Contract No. T200301601.01
Federal Aid Project No. ESTP-K137 (2)
CARTER ROAD (K137)
Kent County

Enclosed is Addendum No. 1 for the referenced contract consisting of the following:

CARTER ROAD (K137)

SHEET NO.	24
TOTAL SHTS.	134

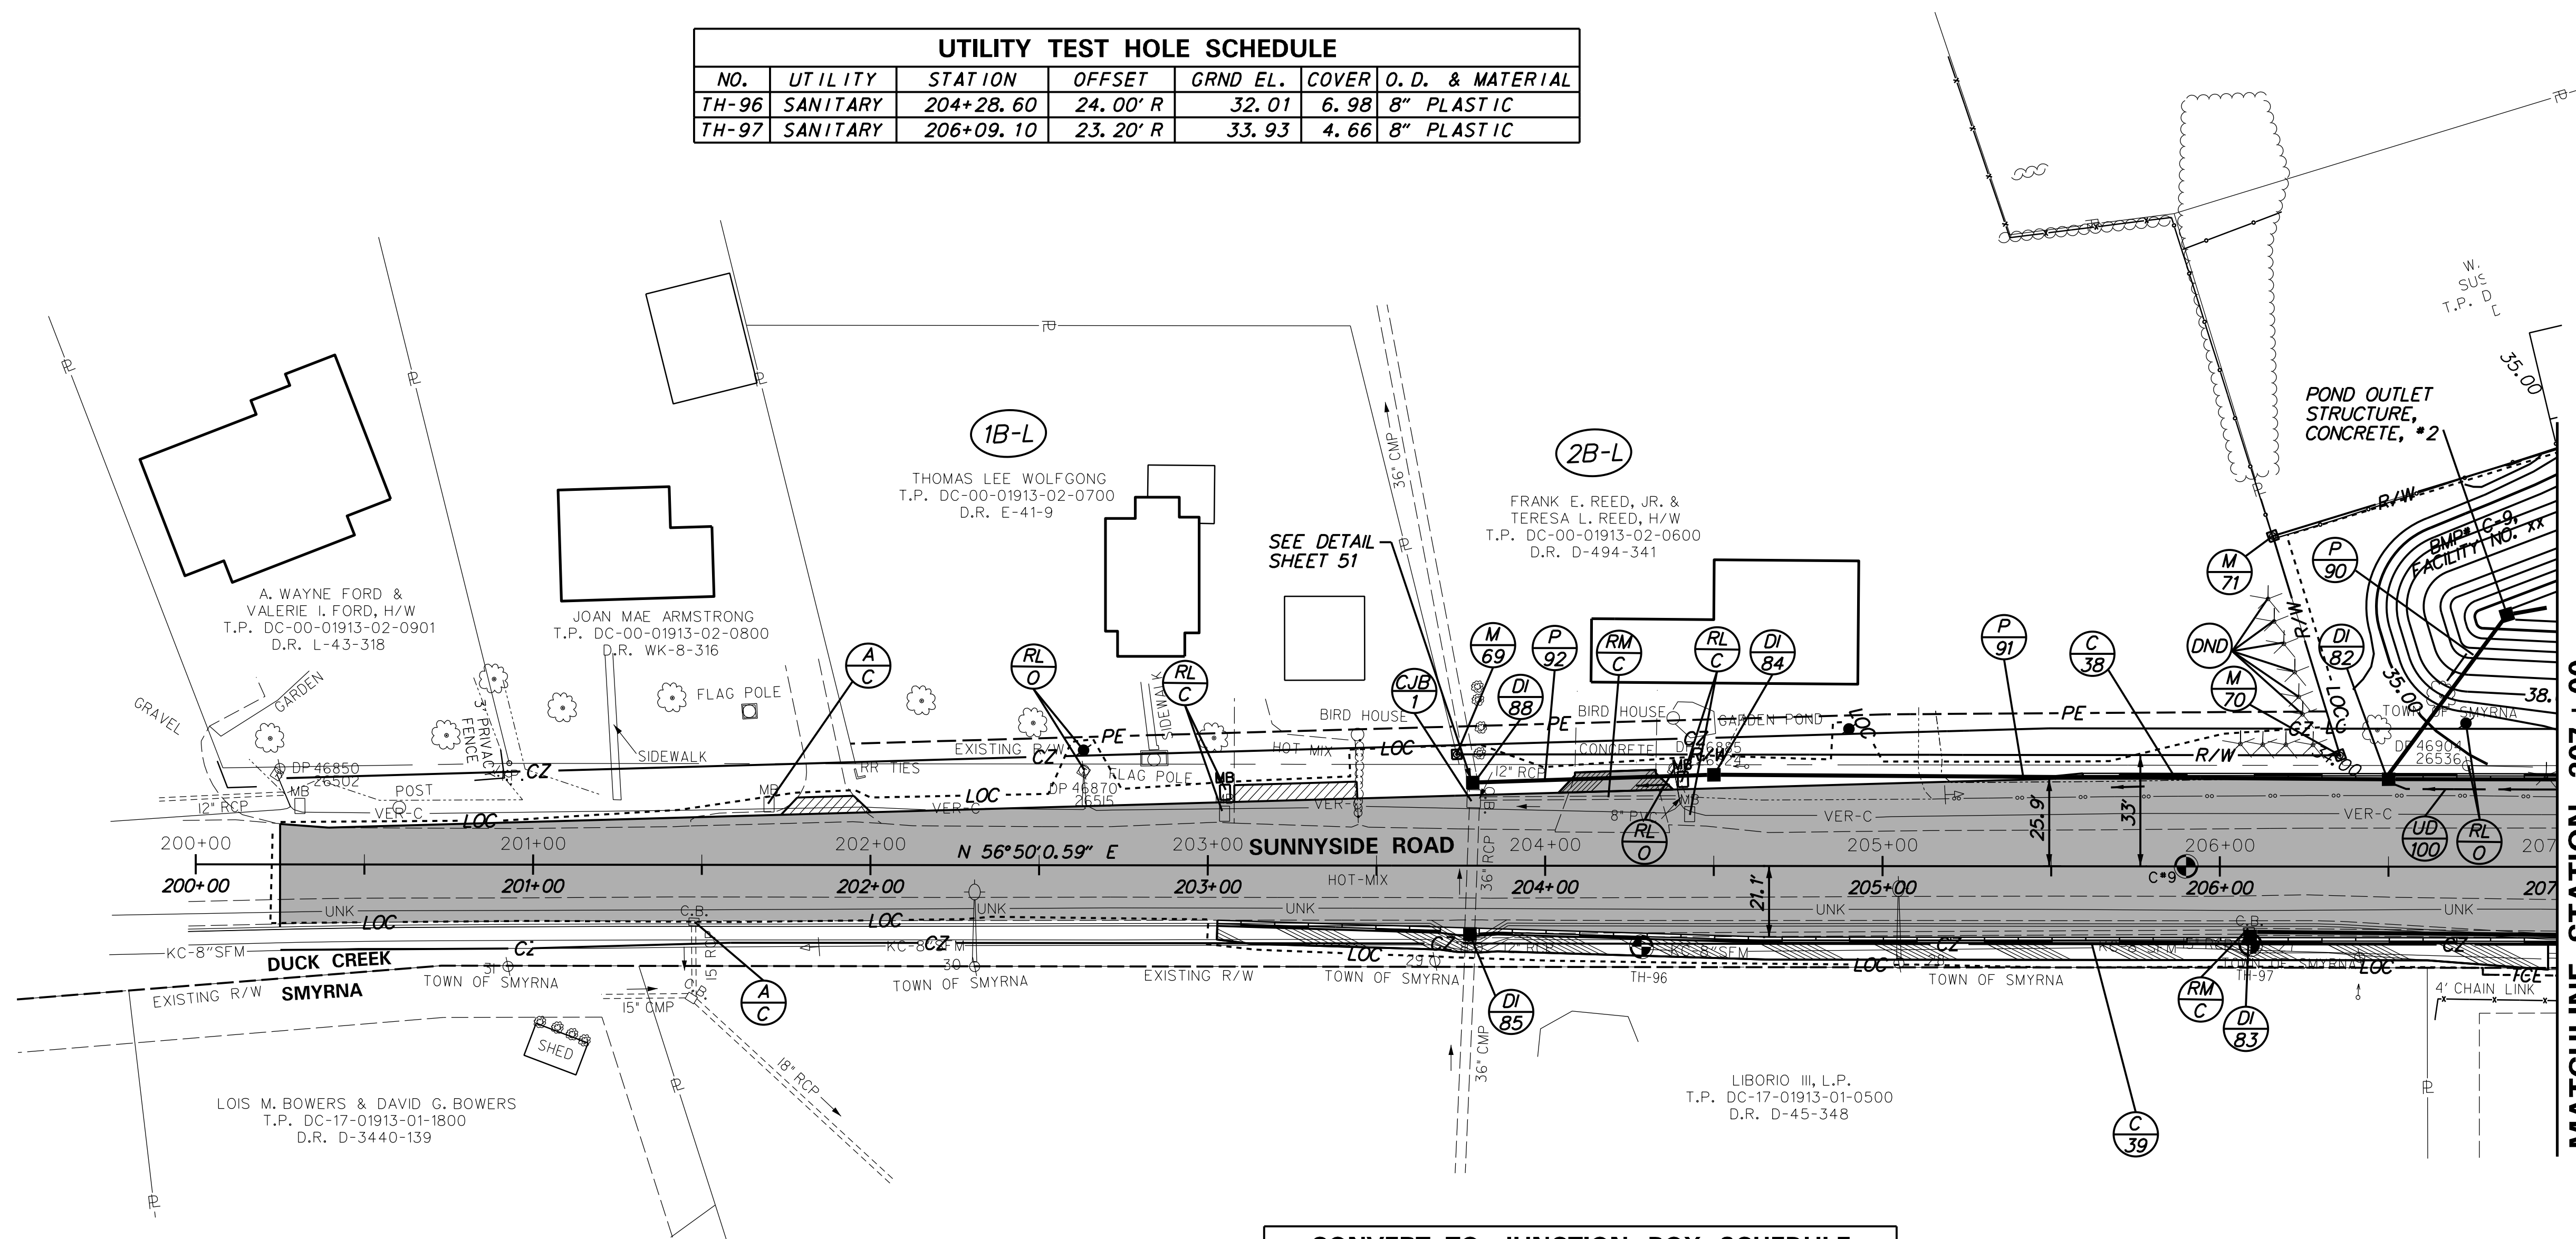
ADDENDUMS / REVISIONS	
▲	REVISED DI-88 SIZE TO 66" X 30"

SHEET NO. 44
TOTAL SHTS. 134

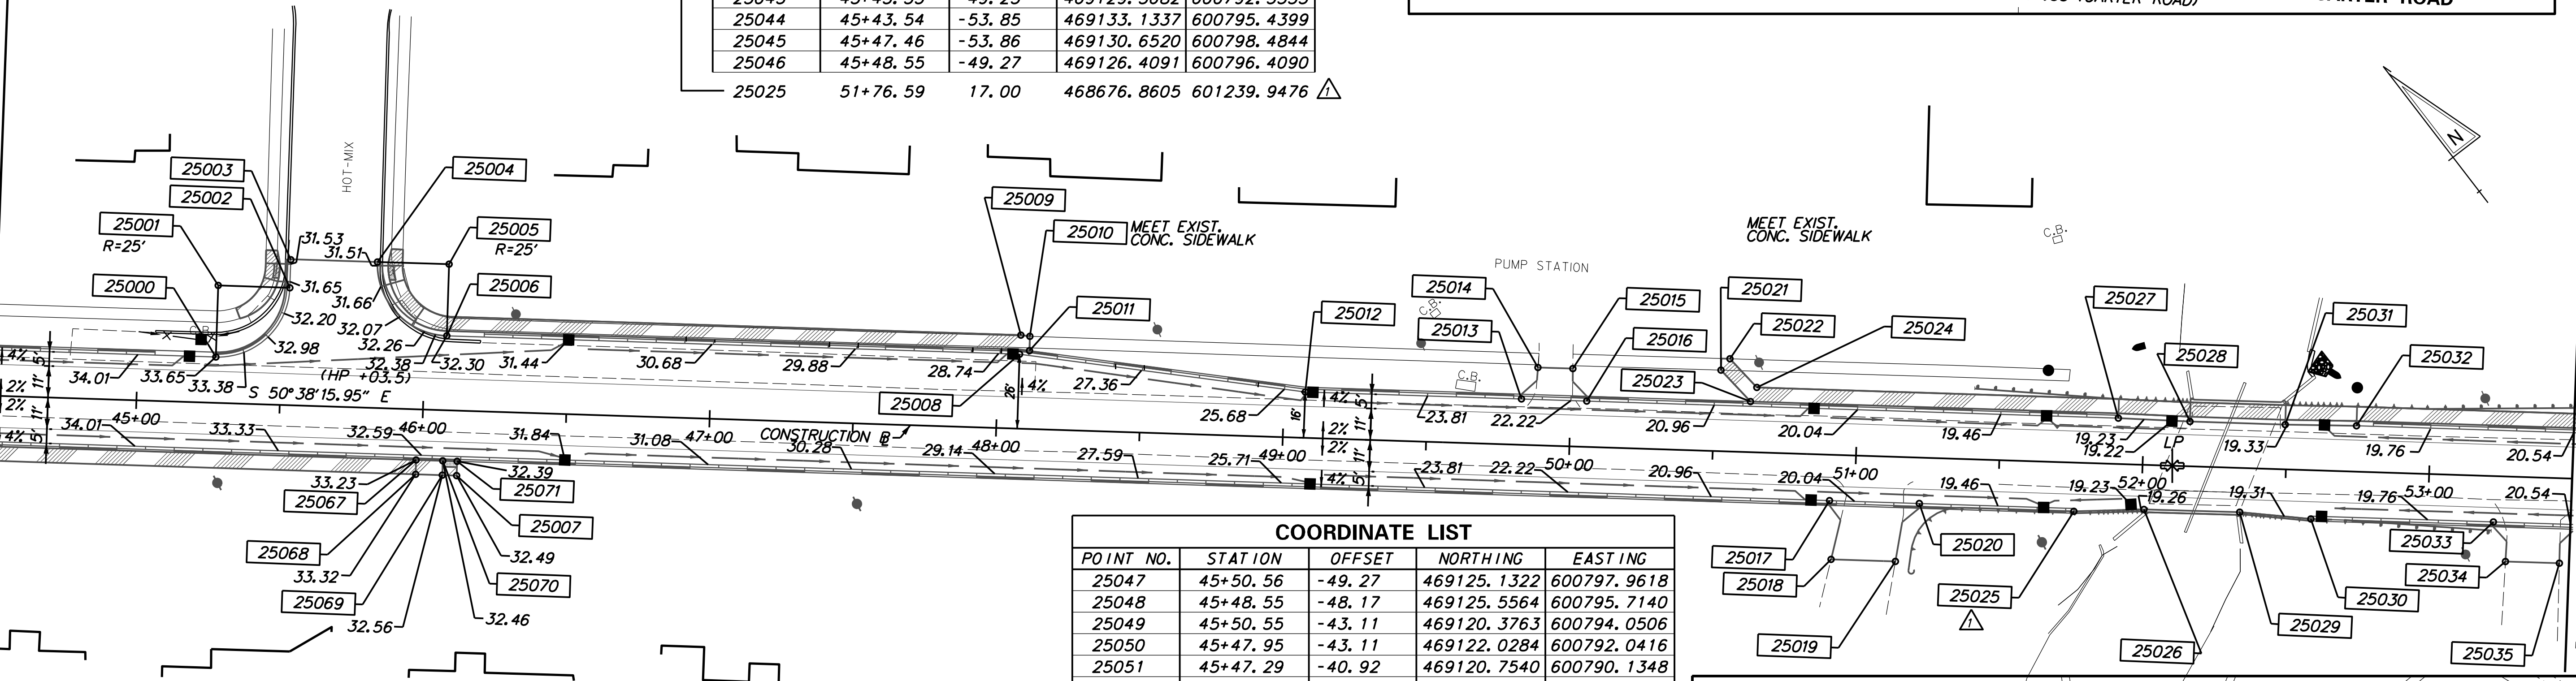
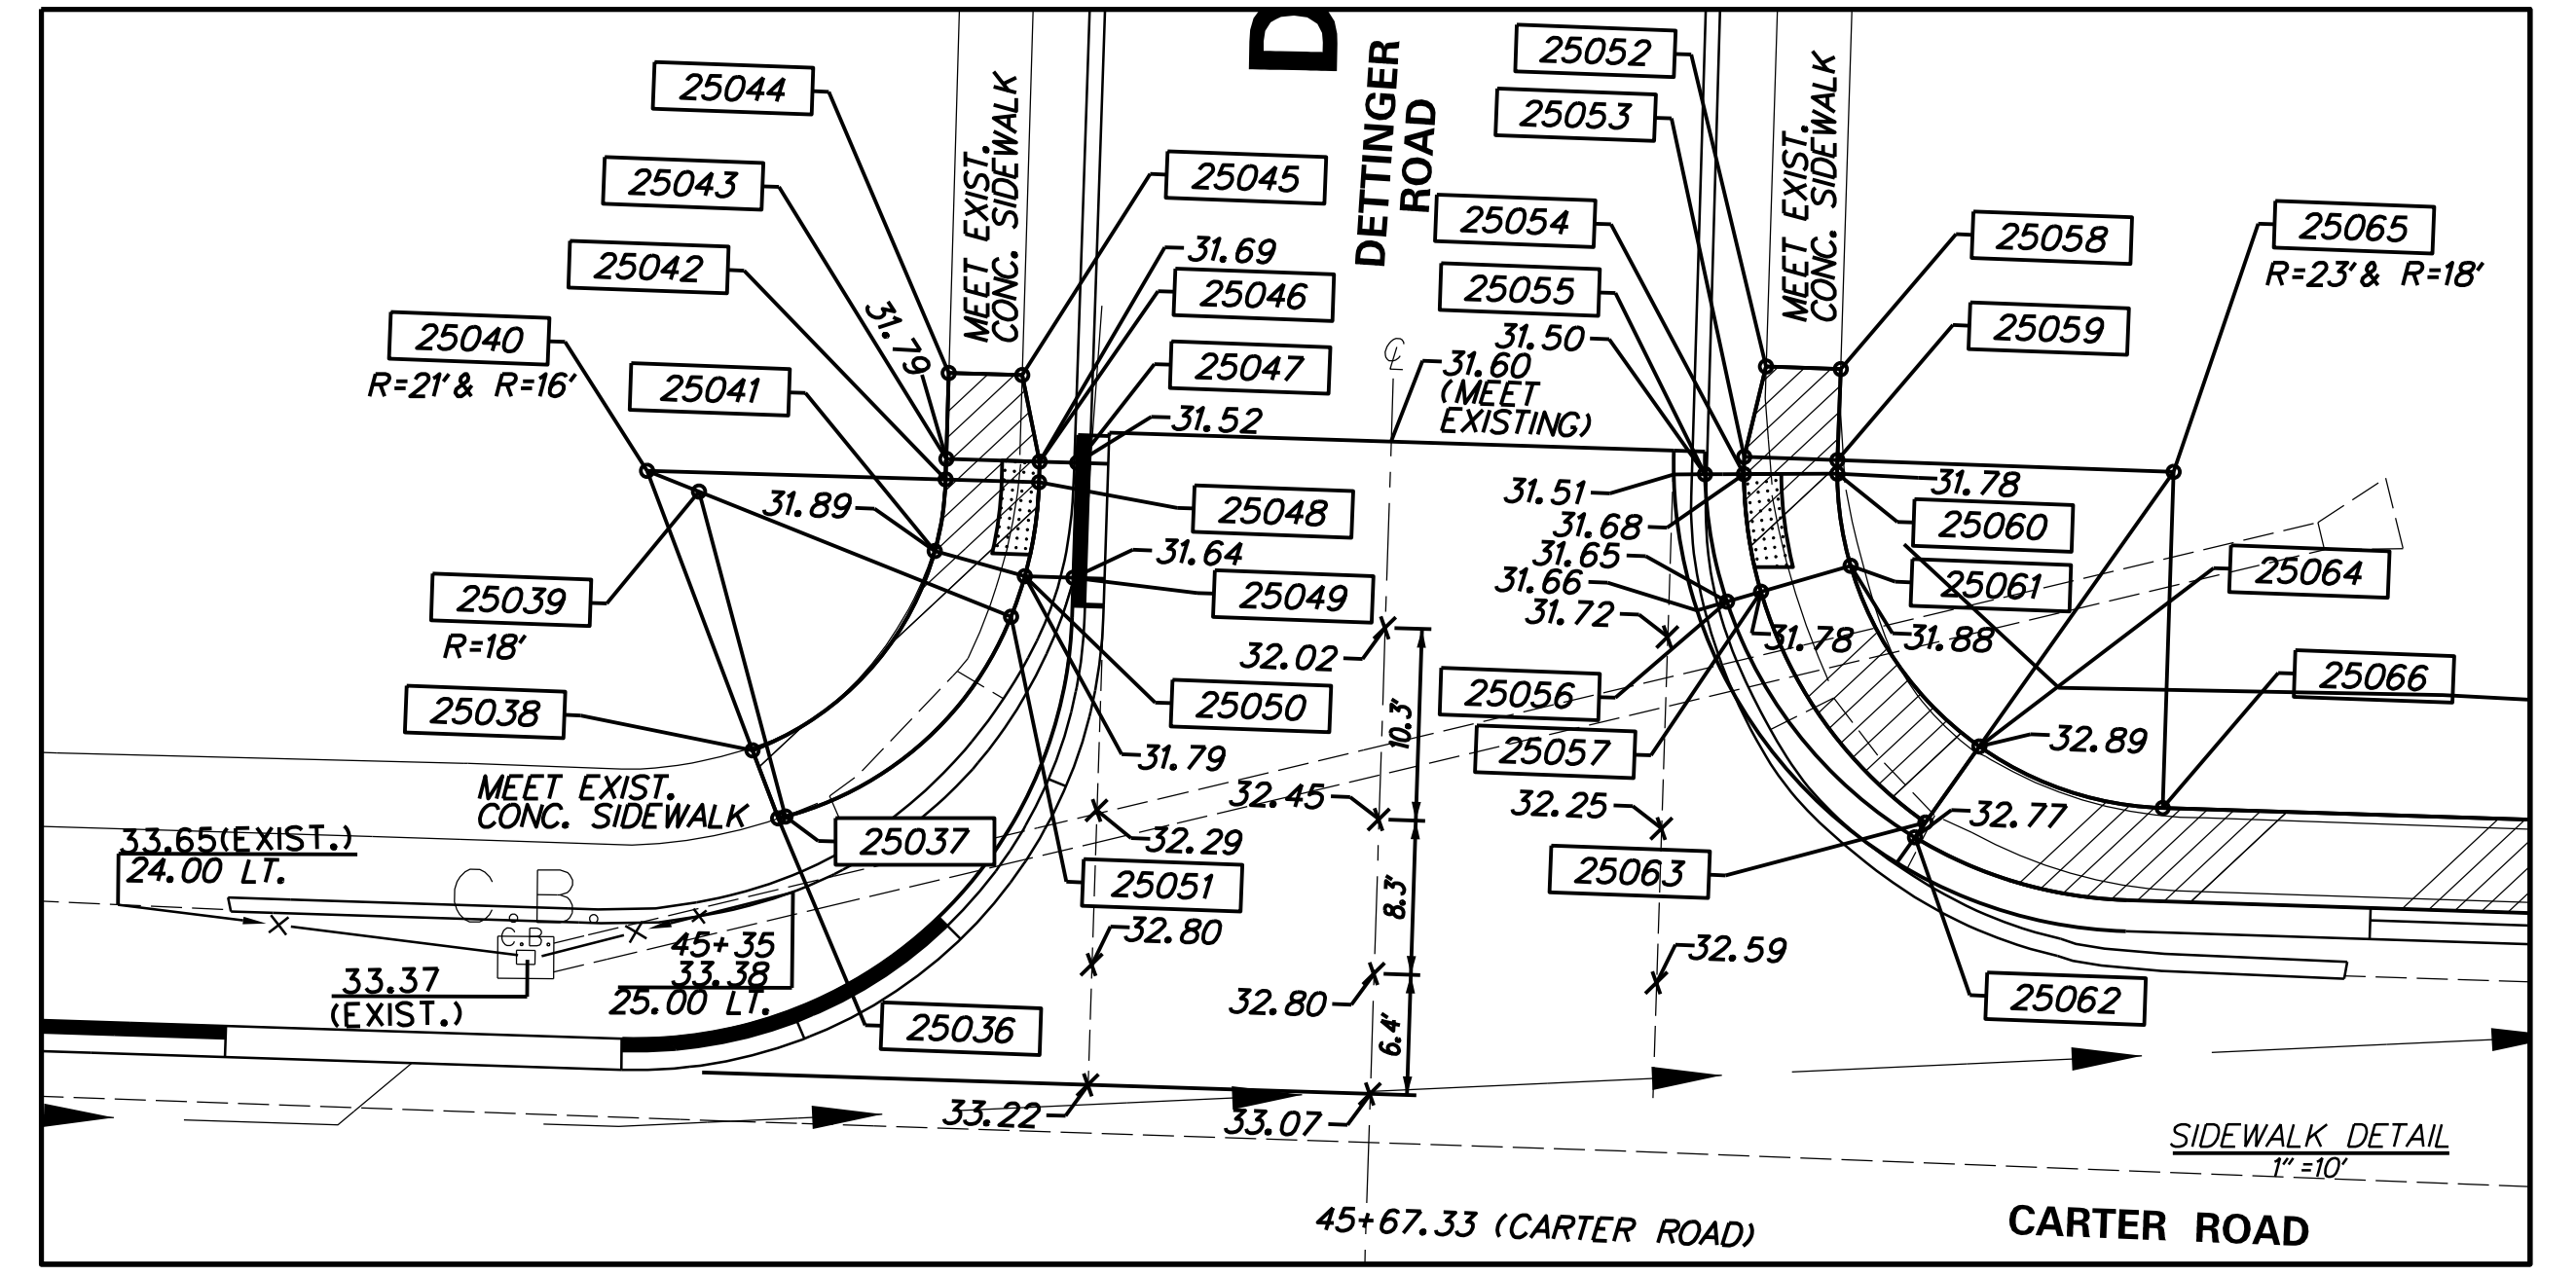
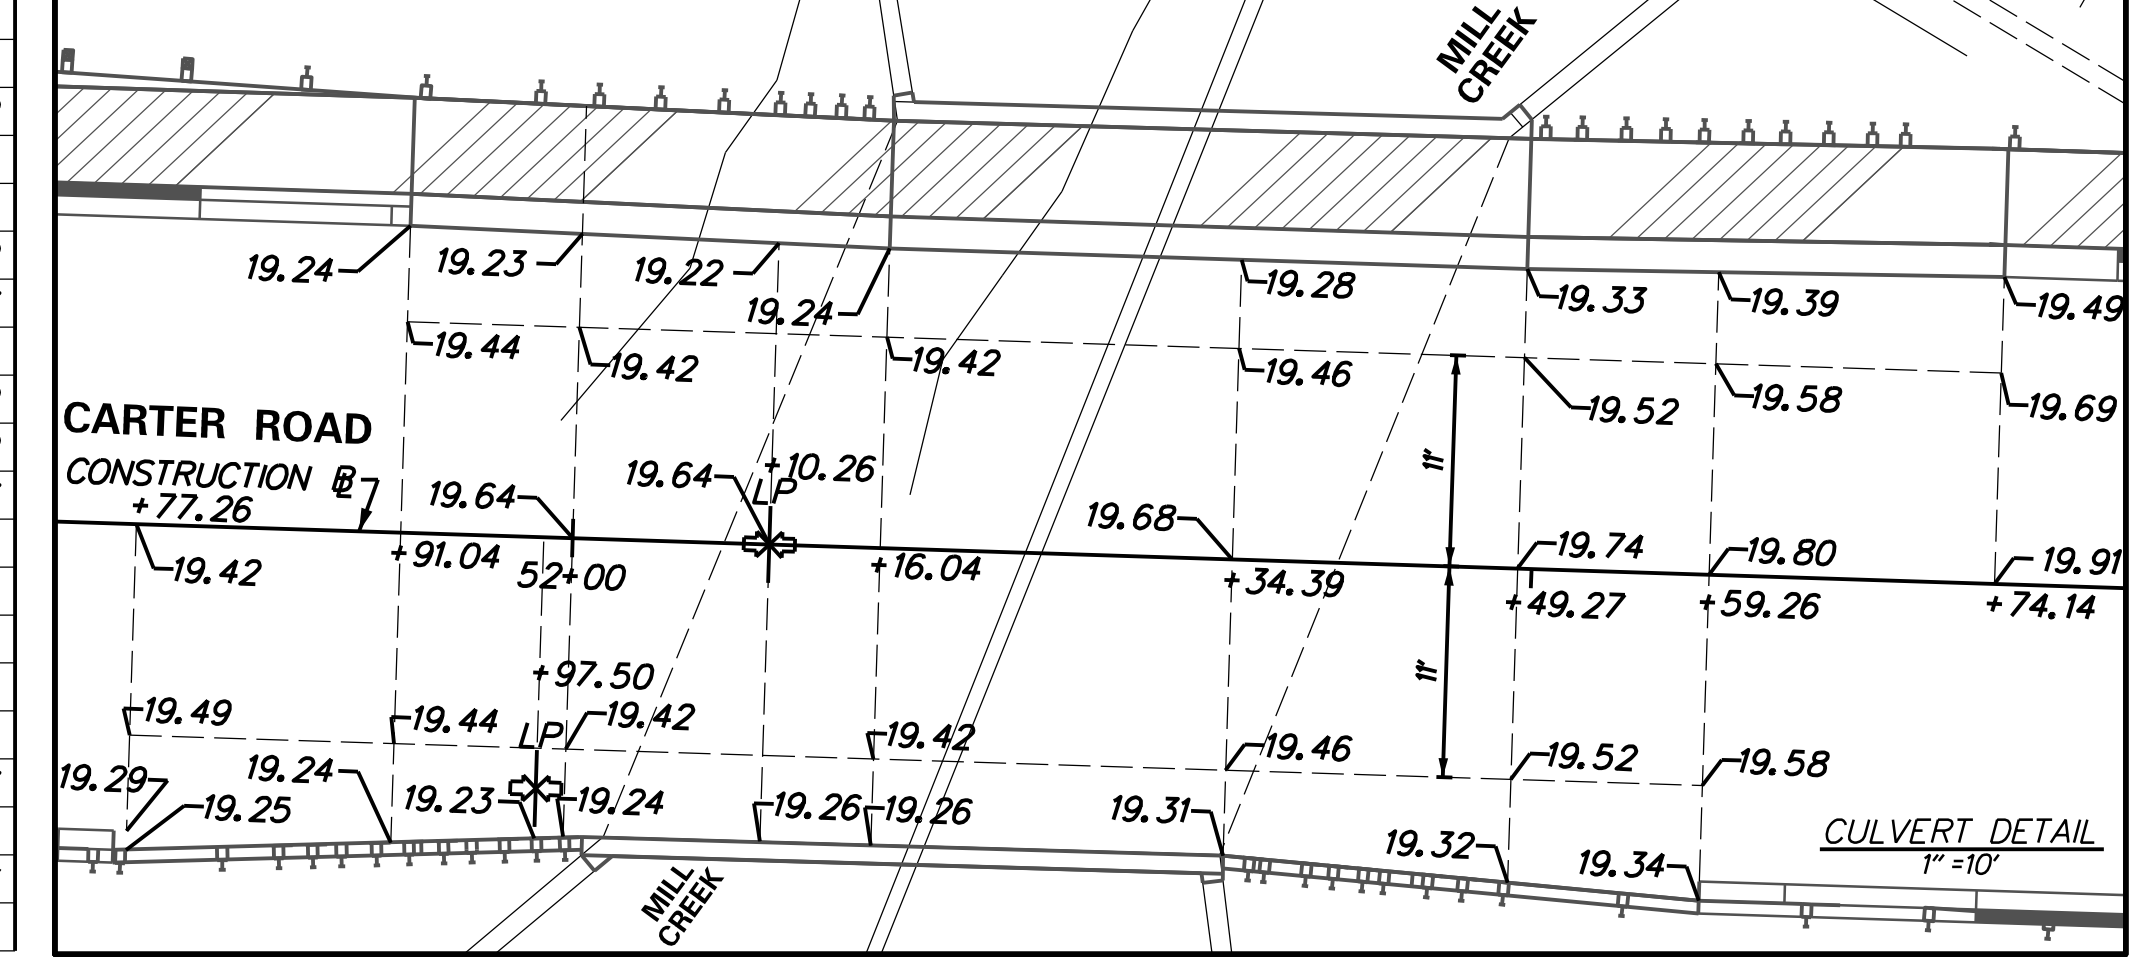
ADDENDUMS / REVISIONS	
1	REVISED POINT NO. 25025
